# TECHNICAL BULLETIN

NO: TB-SC-FRA-004

<b>MODEL AFFECTED:</b>	ALL SPORTCRUISER SERIAL NUMBERS
<b>SUBJECT:</b>	FUEL-TANK FILLER CAP SWELLING
<b>ASSEMBLED AIRCRAFT AFFECTED:</b>	Due to the potential nature and frequency of this problem, this Technical Bulletin can affect all SportCruiser models using Automotive/MOGAS Type fuels.
<b>COMPLIANCE:</b>	Czech Aircraft Works recommends accomplishment of this bulletin IF the effects of fuel additives such as ethanol and other chemicals are affecting the normal operation of the Fuel-cap components or seals.

FIGURE 1.

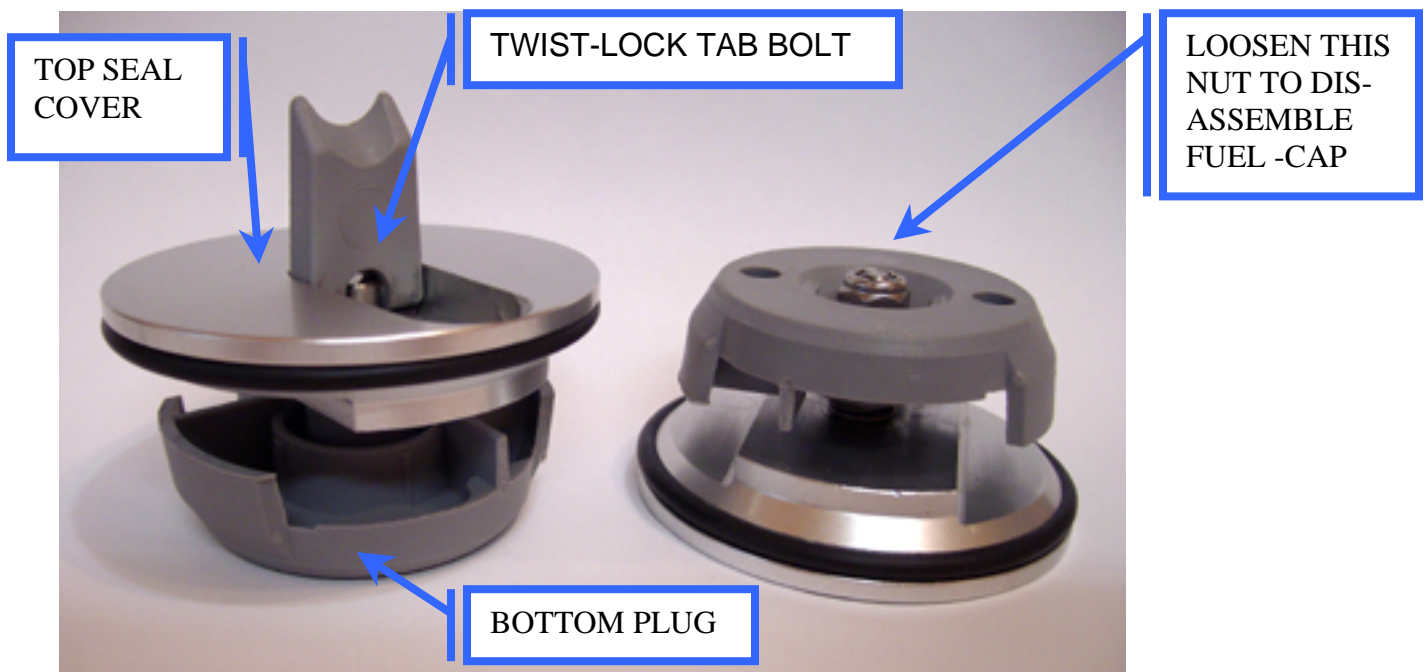
1. Secure the aircraft indoors in a location where it is free of flying dust and debris.
2. Remove the fuel cap from one side and in its place stuff a very clean rag (free of dirt and other debris) in the fuel filler hole or be certain as to ensure nothing foreign can enter your fuel system while it is exposed with the Fuel-cap removed.
3. **TO DISASSEMBLE THE FUEL CAP:** Loosen the nut as shown in the diagram. The cap will come apart when the nut is removed. The cap is an assembly consisting of the twist-lock tab bolt, a spring, the grey circular bottom plug, and the metal top seal cover.

FIGURE 2.

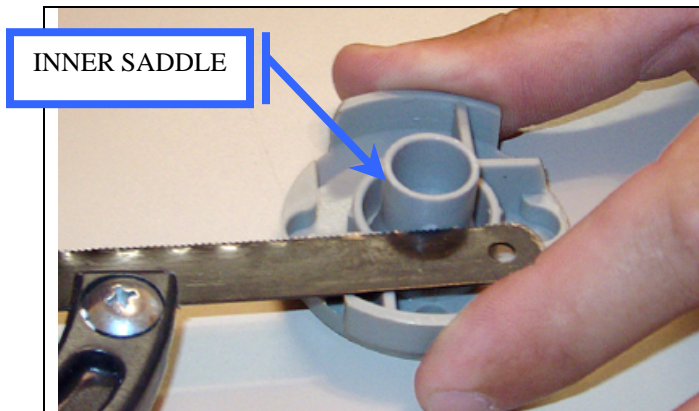
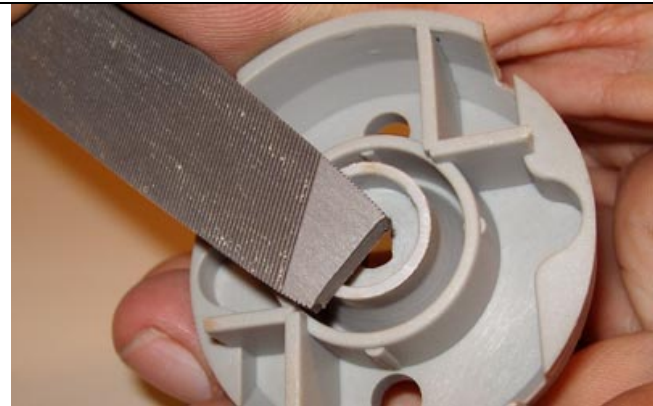
4. The next step is to carefully trim a portion of the saddle off of the bottom plug (this is where the twist-lock tab-bolt passes through). The depth of the cut should be about  $\frac{3}{4}$  of the way down from the top of the saddle as shown in Figure 2 and Figure 3. By decreasing the height of this saddle, it should allow enough clearance for the twist-lock tab to engage and secure, normally and without UNUSUAL binding and/or friction.

FIGURE 5.

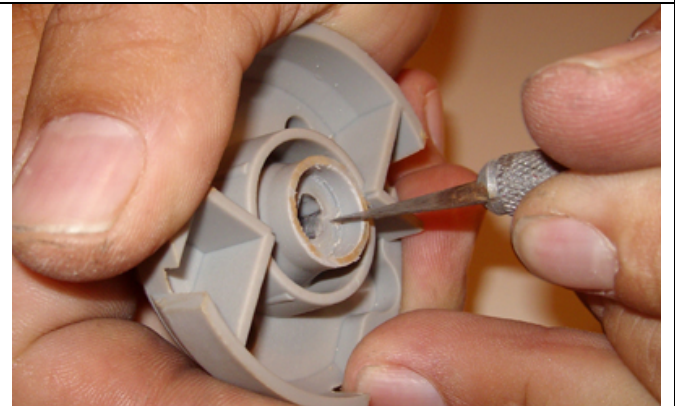
**NOTE:** Use a flat file to ensure the saddle is level and uniform in height around the circumference. Also using an Exacto-knife remove and clean any loosely hanging material from the edges and inside areas of the saddle as shown in Figure 5.

FIGURE 6.

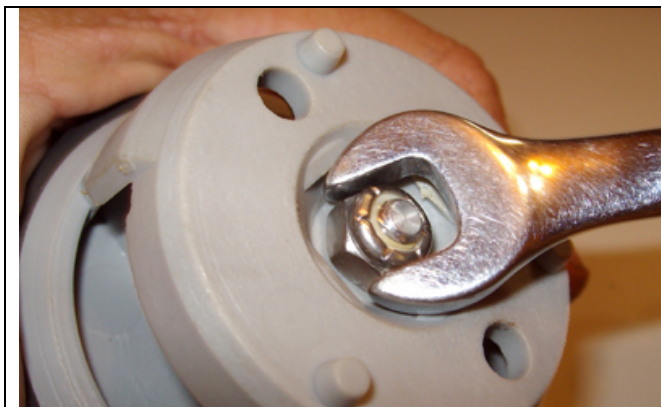
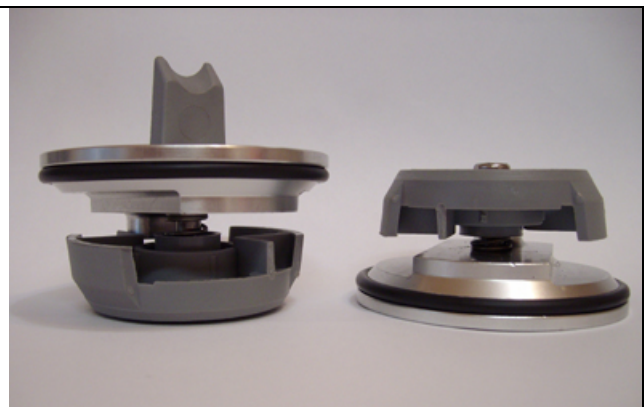
**5. NOTE:** Lubricate lightly with Vaseline: Key-Lock (if applicable), Lever and Center-pin. Proceed with reassembling the fuel cap by passing the bolt in the center holes of the upper and lower pieces. Do not forget the spring that goes between both upper and lower center saddle points. The bolt passes inside of this spring.

Tighten the securing nut of the tab lock-pin bolt to the proper torque value **by adjusting the number of threads to show between 1.5 – 2.0 threads past the nut; it should be such that it compresses and causes the O-ring to expand when the lock lever-tab is rotated to the fully 'CLOSED' position and latched down.** Adjust to a light easy seal, Not tight, not rattling loose. **The installer may need to repeat this process to achieve the correct fit and feel.**
